Permit Application Technical Review: Permit Application: Structure PC2134D – Wind Turbine

Install Wind Turbine Generator - PC2134D

Aeronautical Study No.
2022-WTW-3581-OE

WTG Foundation PC2-134d

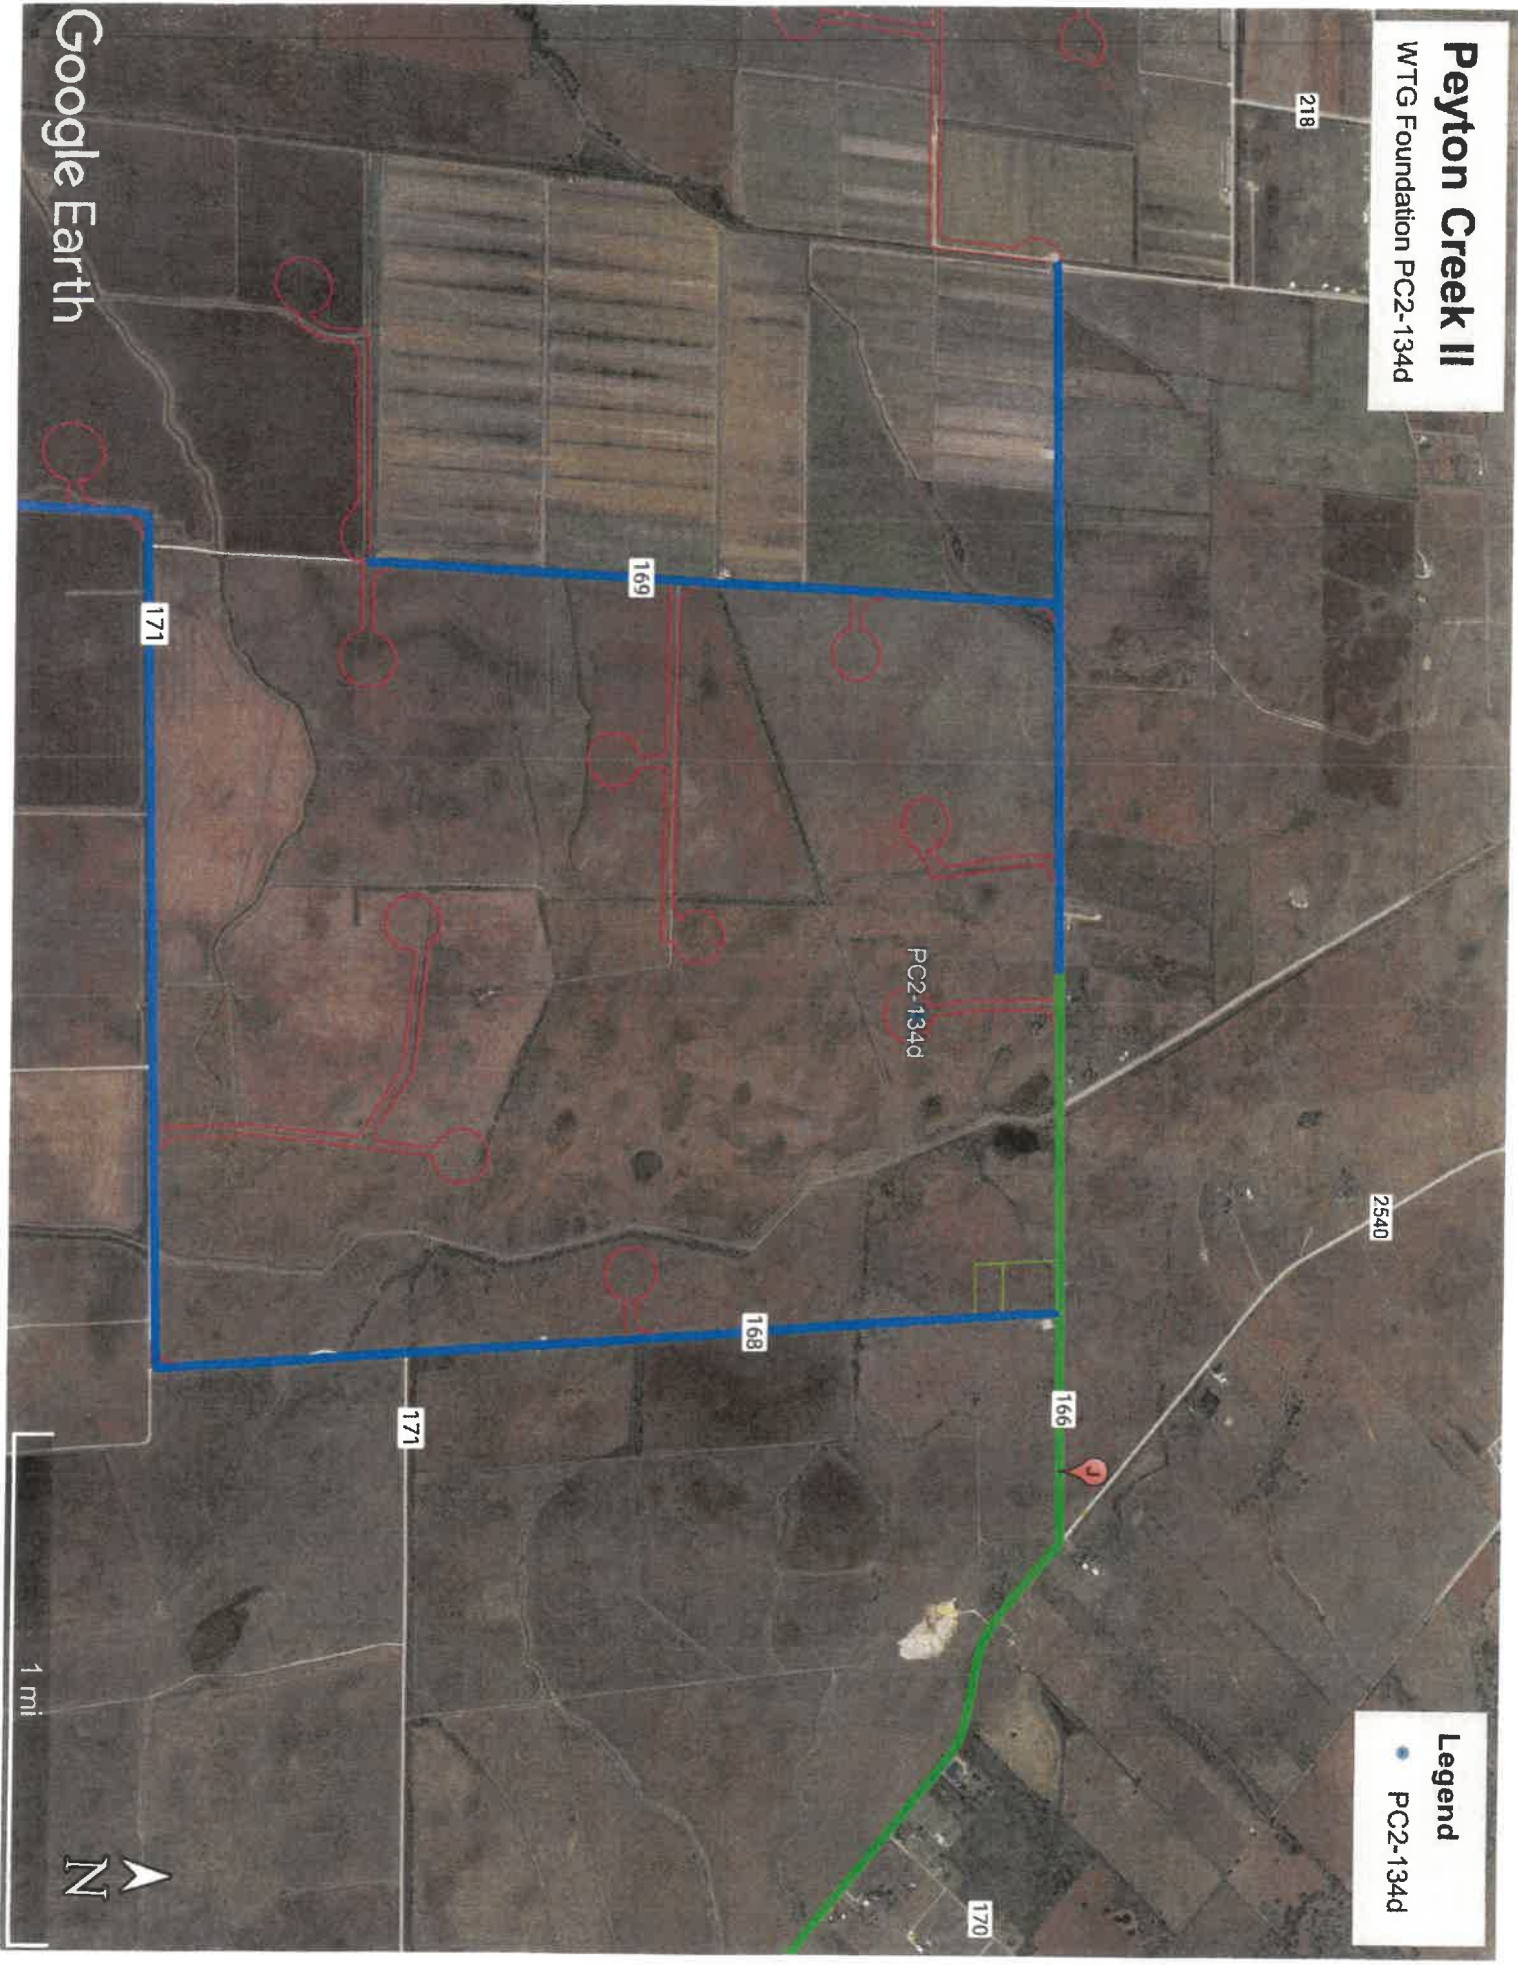
Reasons: This section does not permit use of land or water in the entirety of Matagorda County that might impair visibility in the vicinity of the airport, or otherwise in any way endanger or interfere with the landing, taking off, or maneuvering of aircraft intending to use the airport. This proposed item will affect taking off from the airport:

1. This proposed structure is located 2.88 nm from the end of Runway 31, its departure end. This structure is within the "Diverse Departure Assessment Area" as defined under FAA Order 8260.3D and may require an Obstacle Departure Procedure. For southbound departures from the runway toward the proposed structure, the climb gradient needed to provide proper clearance over the structure will exceed the standard climb gradient; this has been noted in the airspace determination letter of March 15, 2023. Such a requirement interferes with operating out of the airport compared to the operating requirements today.

Based on the information provided above, we find this proposed structure to be contradictory to the zoning ordinance and hereby do not recommend approval of this structure.
